Subject: **Request for Modification of Section 404 General Permit No. 198200031 and Section 401 Water Quality Certification, and lifting of Notice of Violation Status** for the Interstate 85 (I-85) widening and interchange improvements from north of NC 73 to north of SR 1280, Cabarrus and Rowan Counties, Divisions 9 and 10. Federal Aid Project No. NHIMF-085-2(61)55, TIP I-3802A.

The North Carolina Department of Transportation (NCDOT) requests modification to the existing General Permit No. 198200031 and associated Water Quality Certification for widening and interchange improvements along I-85 in Cabarrus and Rowan Counties. This project is currently under construction.

Revisions have been made to seventeen impact sites and are discussed in detail below. Two new impact sites are also discussed below (Site 36 and the Troutman waste site).

**SITE #30**

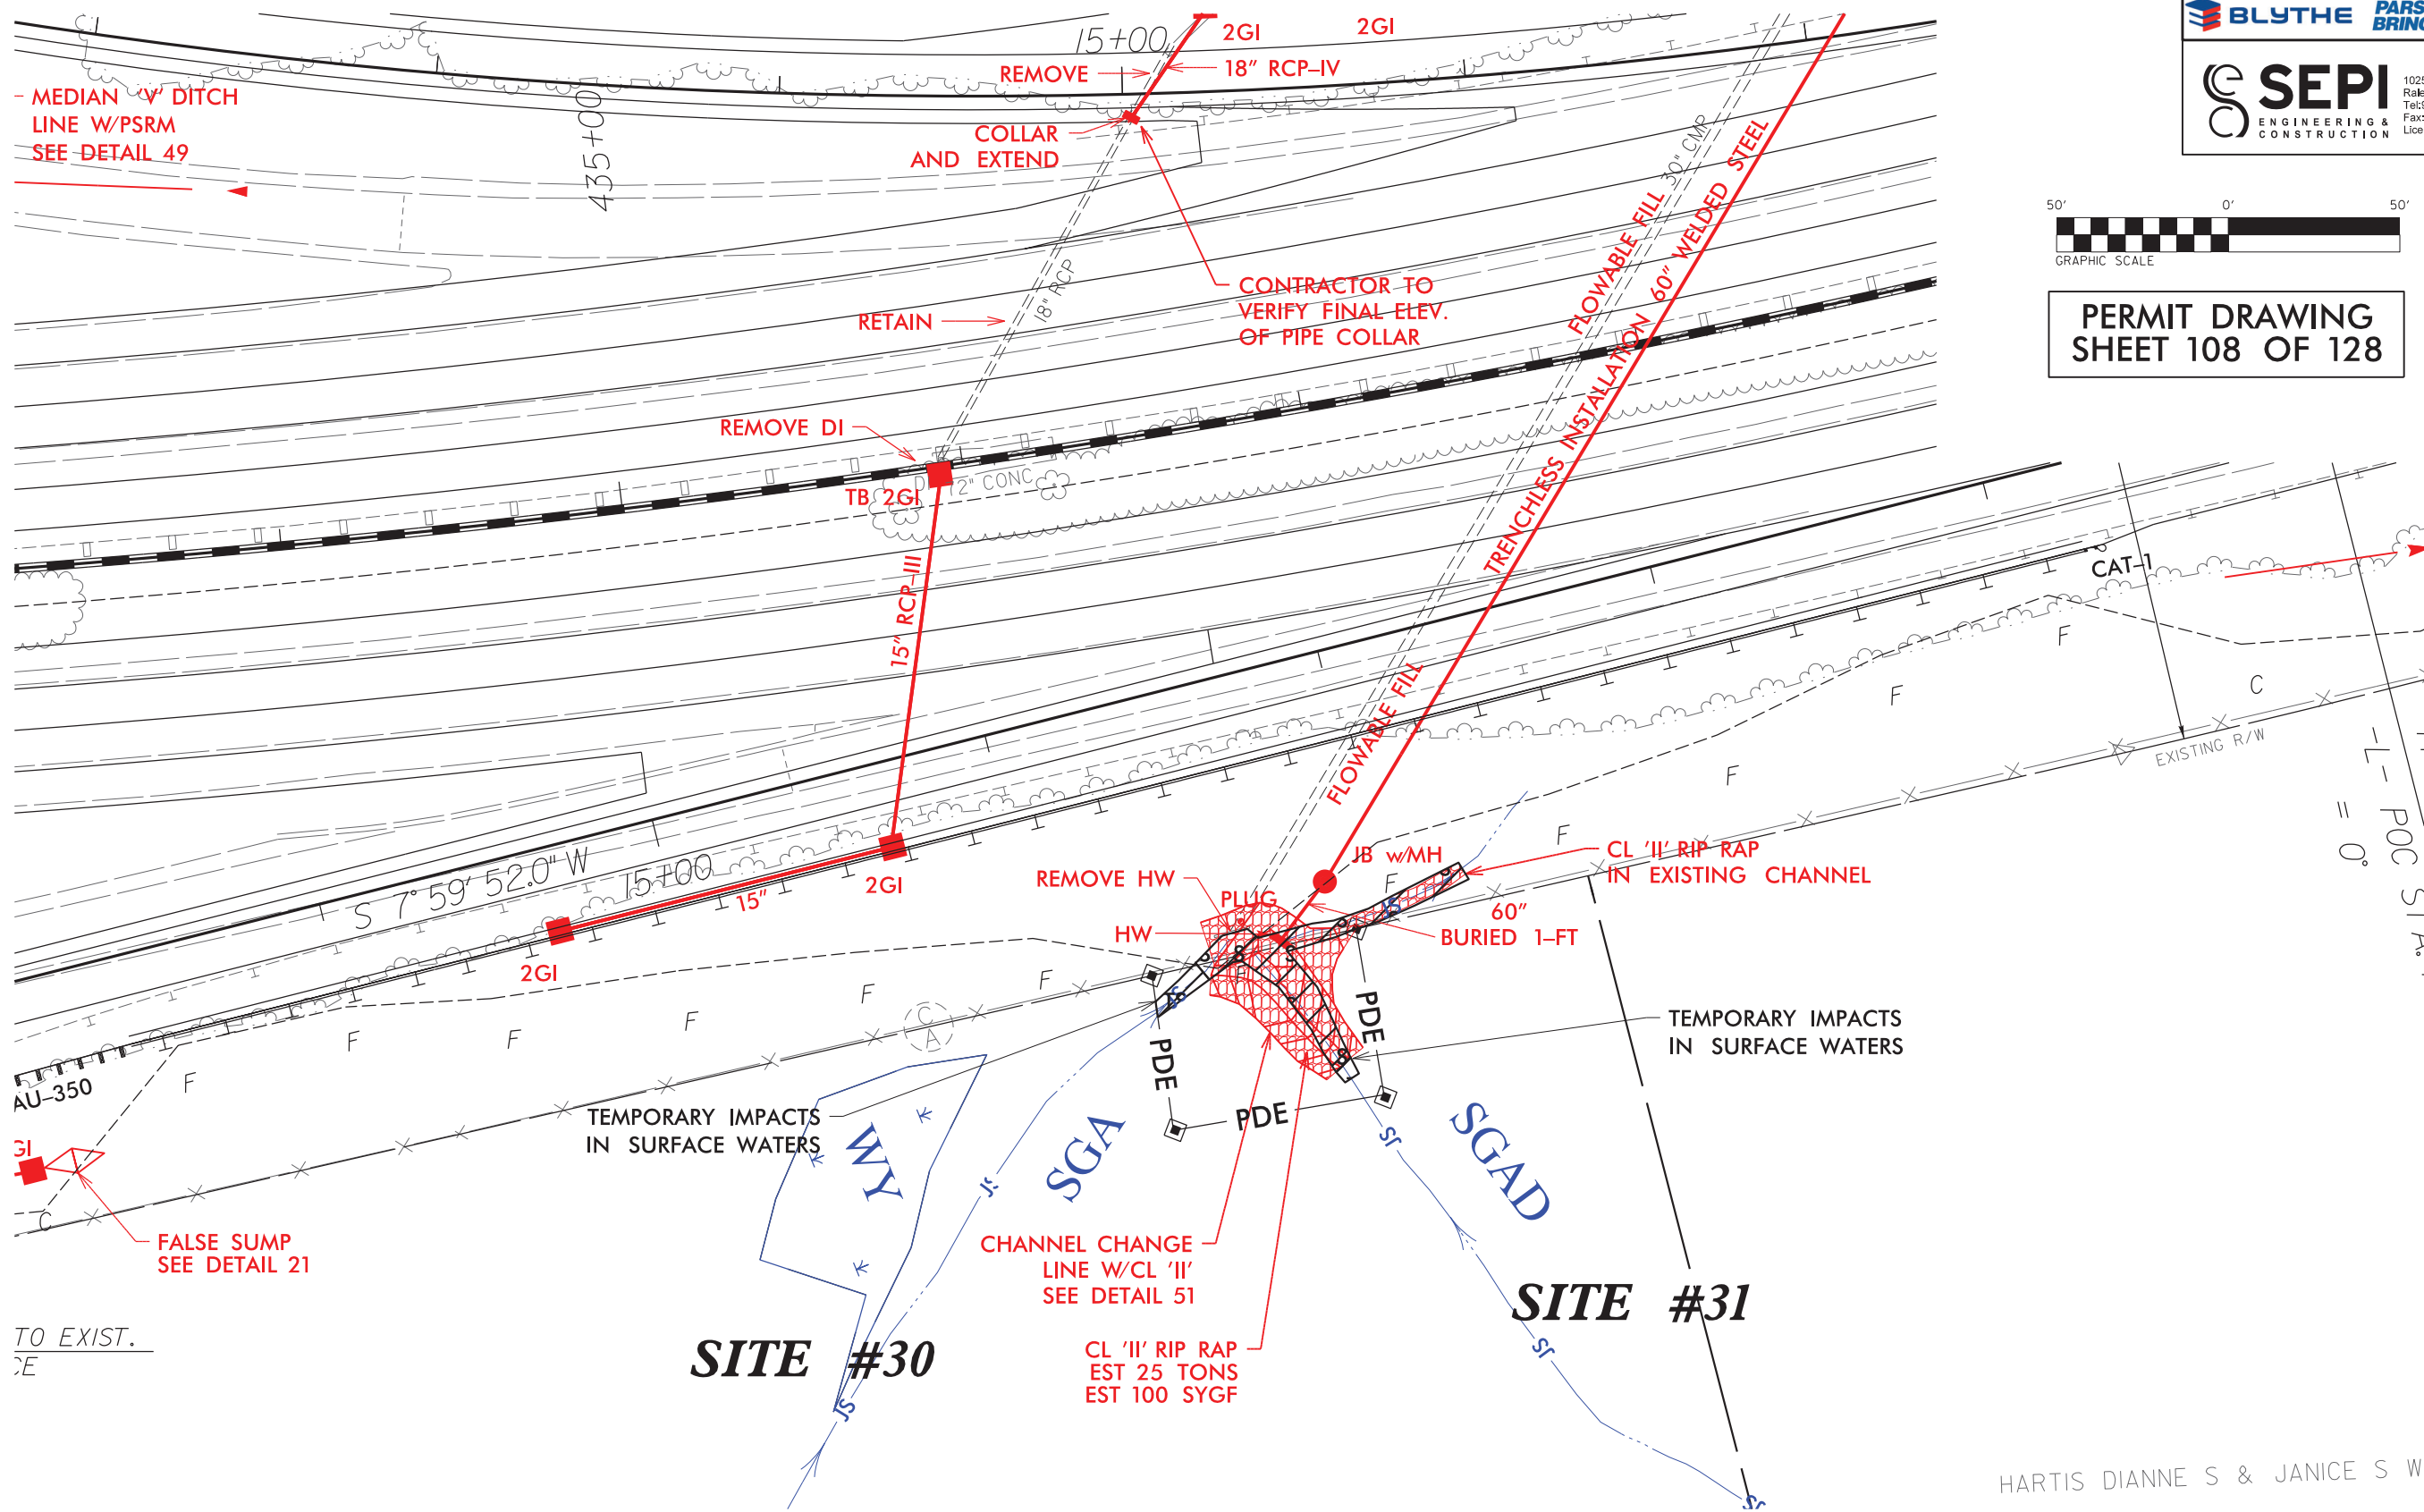
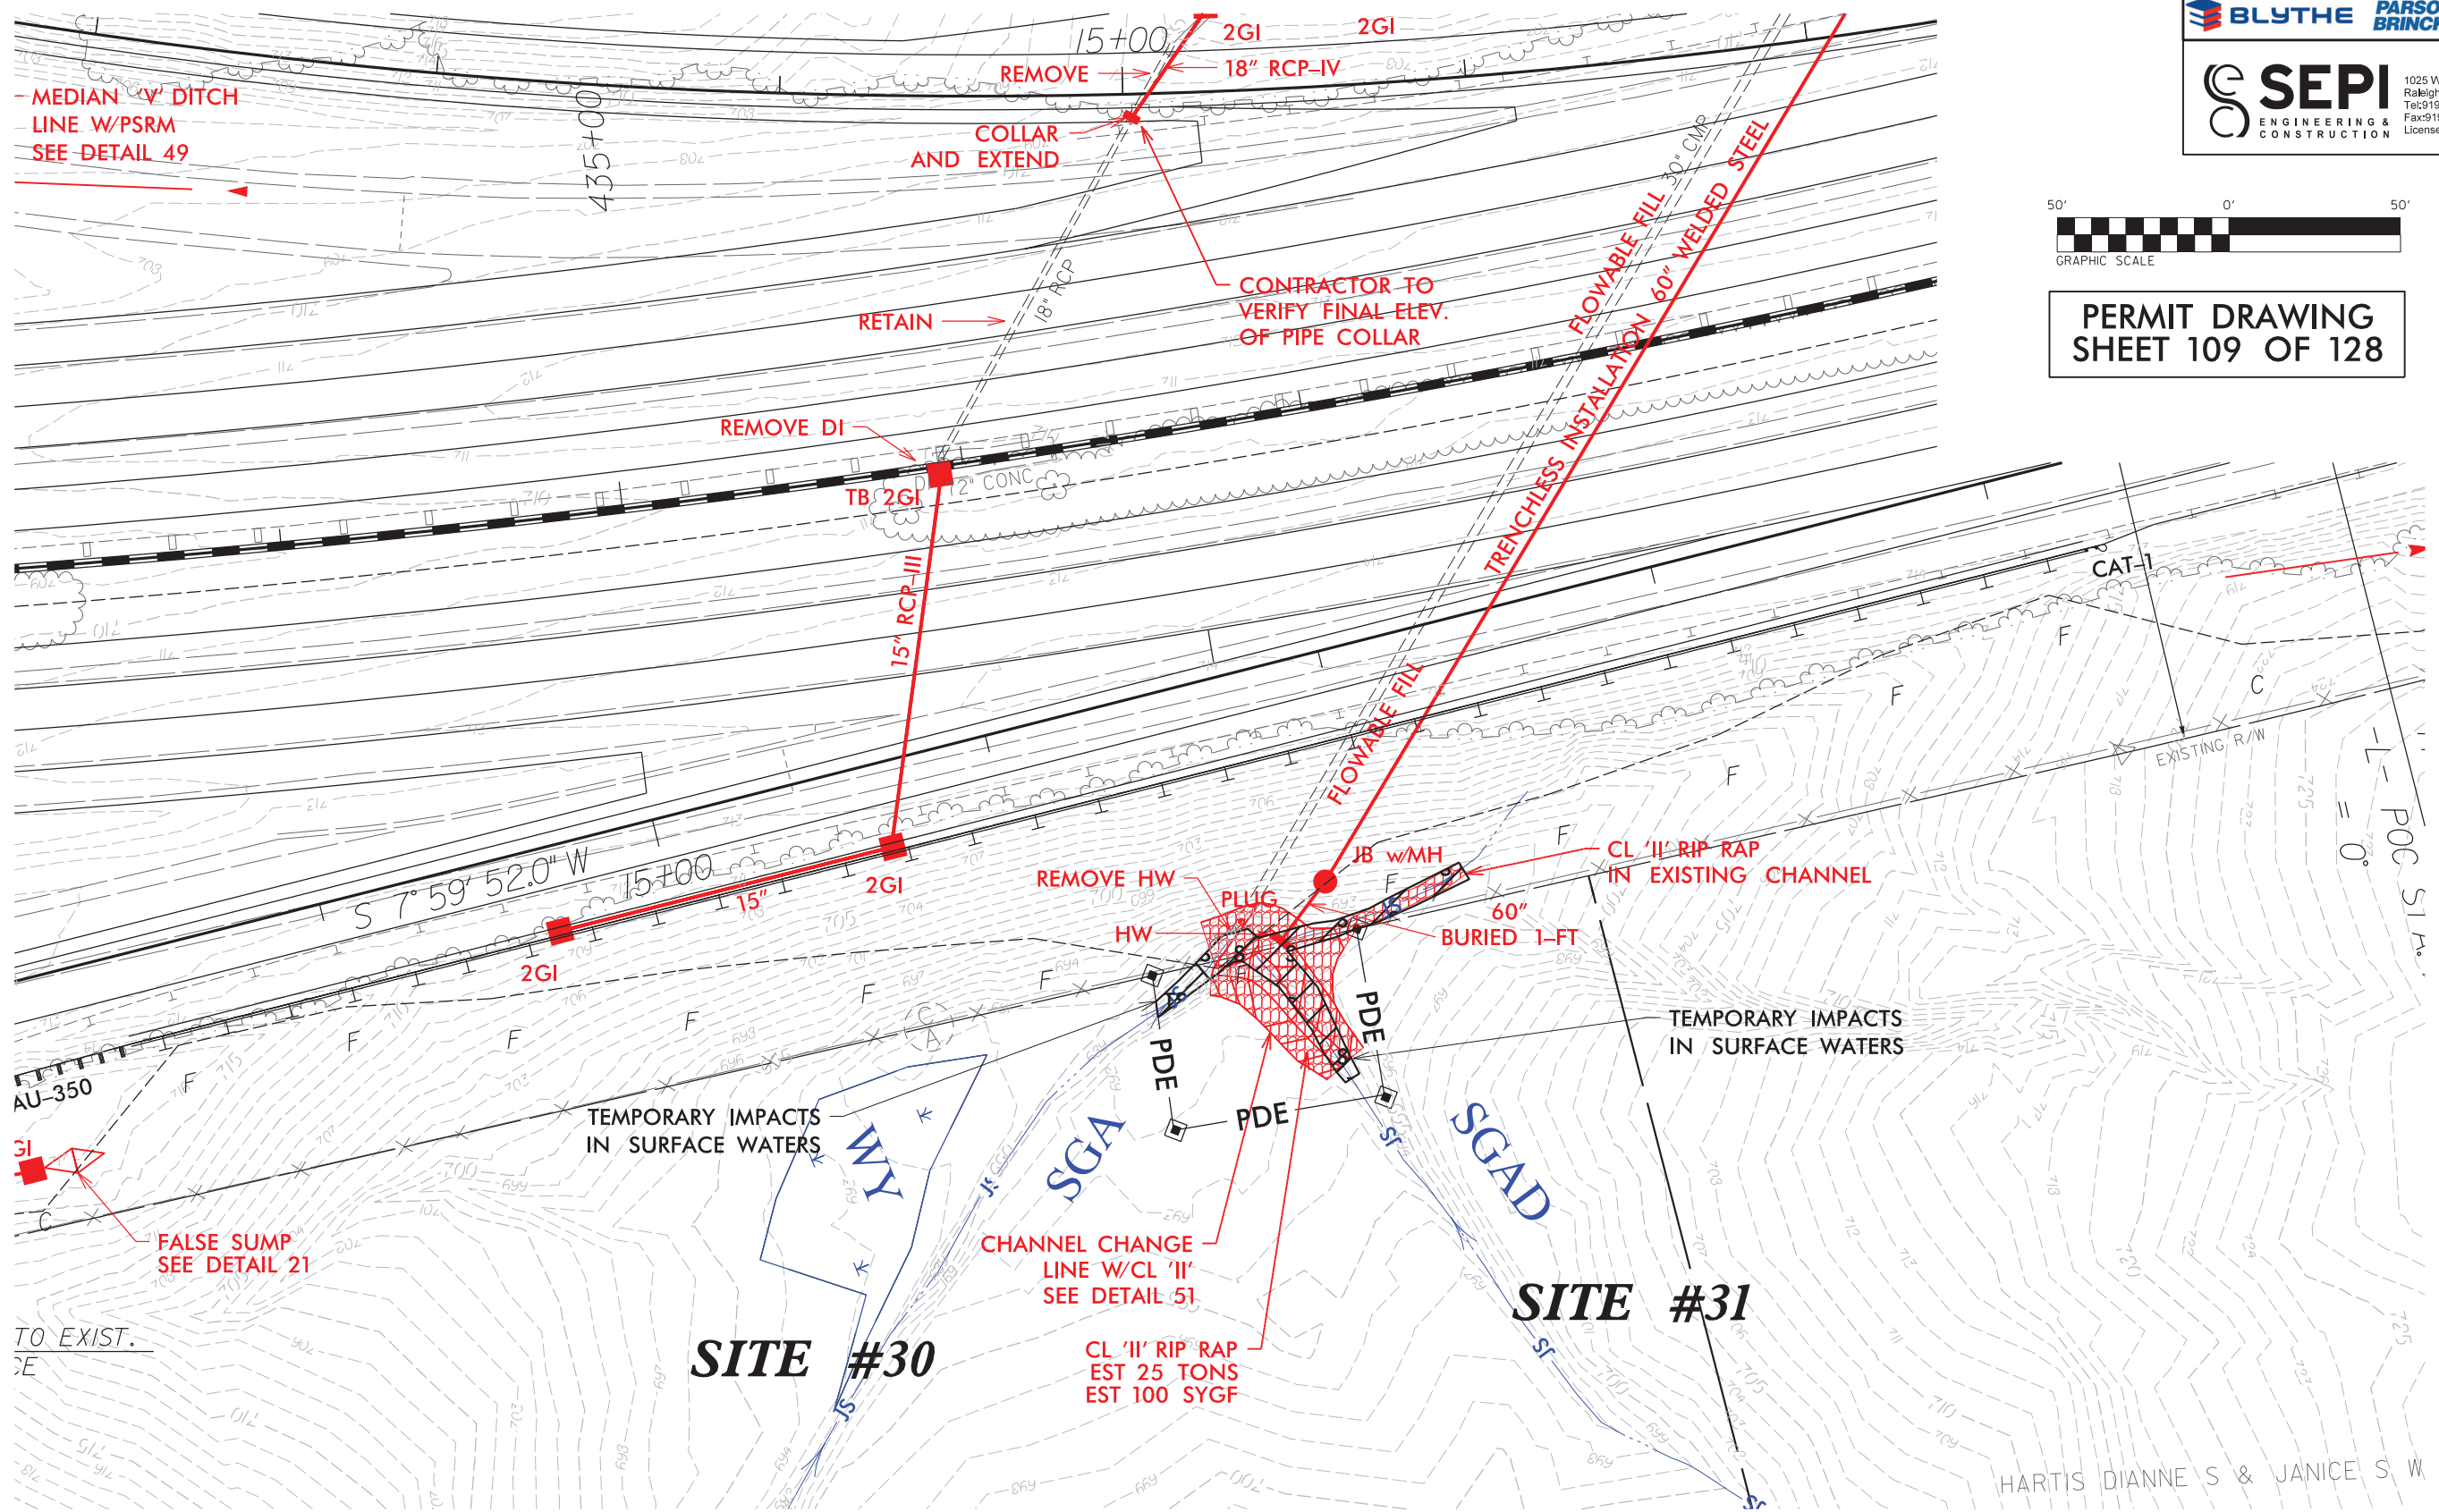
Site 30 (Sheet 29) – The drainage design was revised to allow for maintenance of flow during the installation of a replacement culvert. This required modifying the stream SGA channel at the culvert inlet and an addition of a channel change at the outlet end of the culvert. Permanent stream impacts increased from 44 linear feet to 134 linear feet, which is 90 linear feet of additional impacts. Stream bank stabilization impacts decreased from 71 linear feet to 0 linear feet. Temporary stream impacts increased from 21 linear feet to 25 linear feet, which is 4 linear feet of additional impacts.

Site 31 (Sheet 29) –The drainage design was revised to allow for maintenance of flow during the installation of a replacement culvert. This required modifying the stream SGAD channel at the culvert inlet. Permanent stream impacts increased from 37 linear feet to 116 linear feet, which is 79 linear feet of additional impacts. Temporary stream impacts decreased from 11 linear feet to 5 linear feet, which is 6 linear feet less of impacts.
